SERVICE BULLETIN

#0004

SUBJECT: Placement of the ELT antenna

MODELS AFFECTED: All Sling LSA, Sling 2, Sling Taildragger & Sling 4 aircraft where an ELT is installed

ASSEMBLED VIEW
 (DETAIL A)

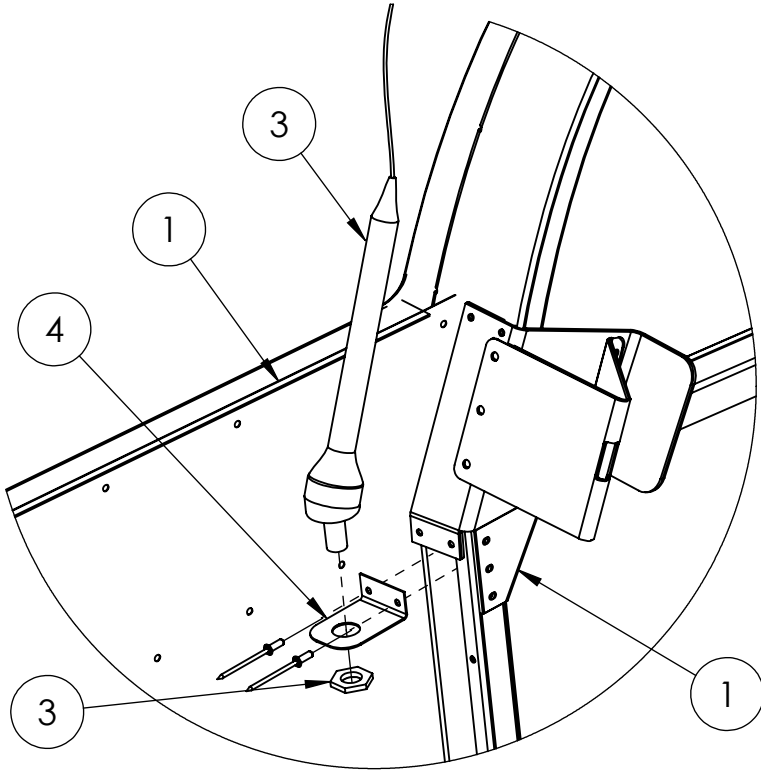
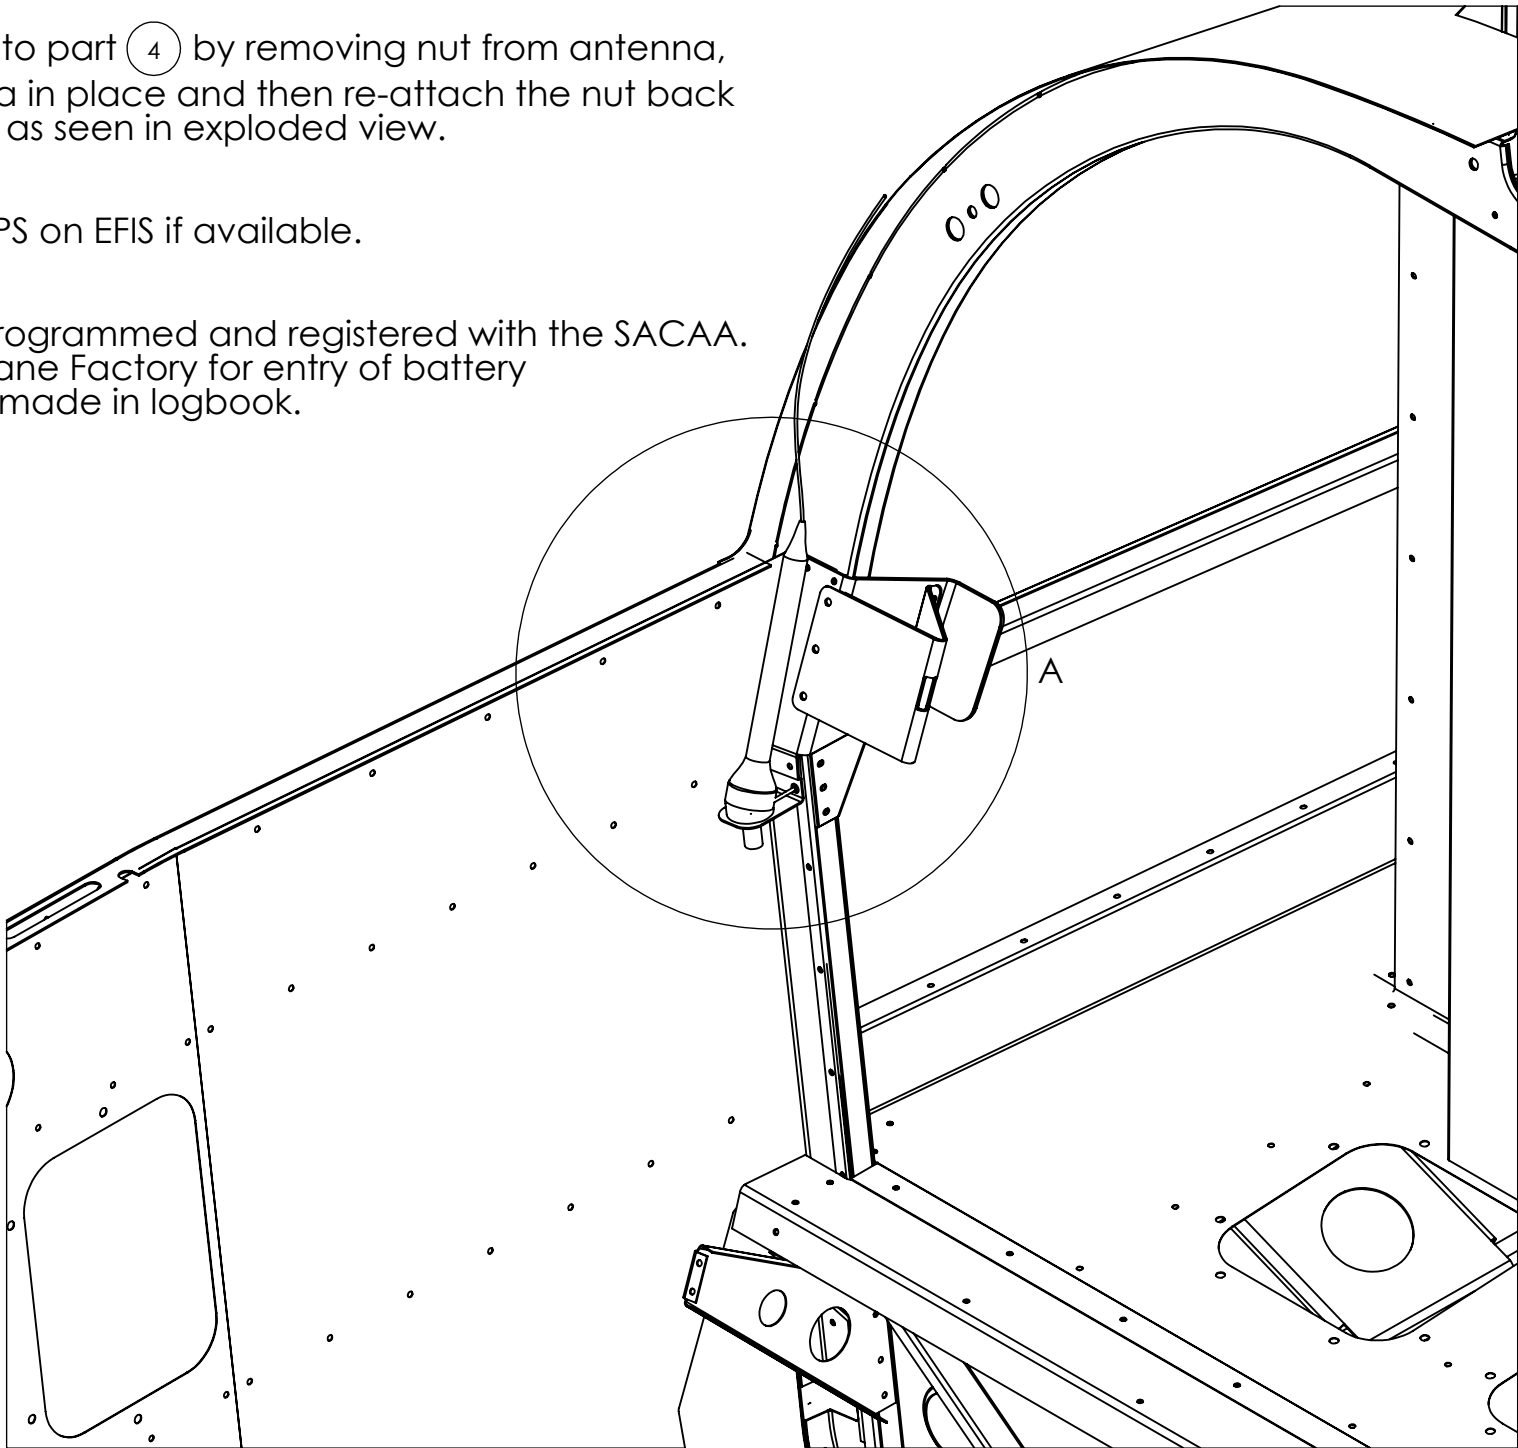
If the ELT antenna is mounted in any place other than what is stipulated in this service bulletin, then this service bulletin will apply. The installation instructions illustrate the correct installation.

Step 1
 Whilst holding part (4) below the bottom flange of the right hand seat backrest stop (as seen in assembled view)drill first 3.3mm hole and cleco, then drill second hole.

Step 2
 Rivet part (4) with two 3.2 x 8mm Aluminium Domed Rivets into the holes drilled in step 1.

Note:
 The antenna will lie loose against the inside of the fuselage skin
